November 17, 2009

Subject: Fuel Leak Case No. RO0002985 and Geotracker Global ID T10000000423, Shell #16-5112, 4895 Hacienda Drive, Dublin, CA 94568 – Conditional Work Plan Approval

Modified Site Das Attachment

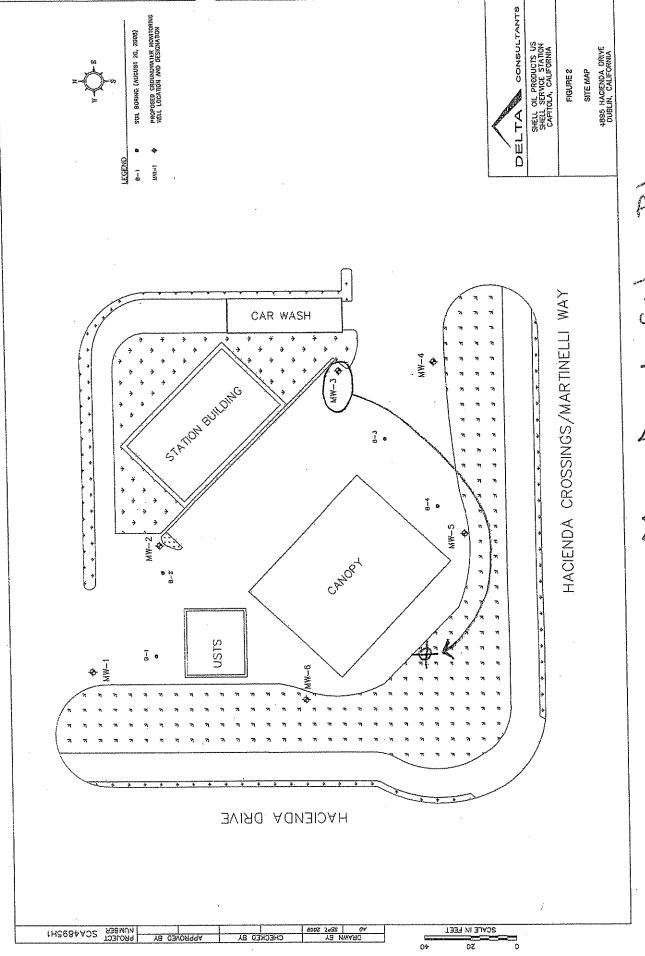
1. Proposed Well Locations. The proposed well locations are generally acceptable; however, we request one modification to the proposed well locations as shown on the attached figure entitled, "Modified Site Plan." We request that well MW-3 be moved to a location that is more likely to be downgradient from the fuel system. Please present the soil boring logs, well completion diagrams, screening results, and analytical results from the wells in the Well Installation and Destruction Report requested below.
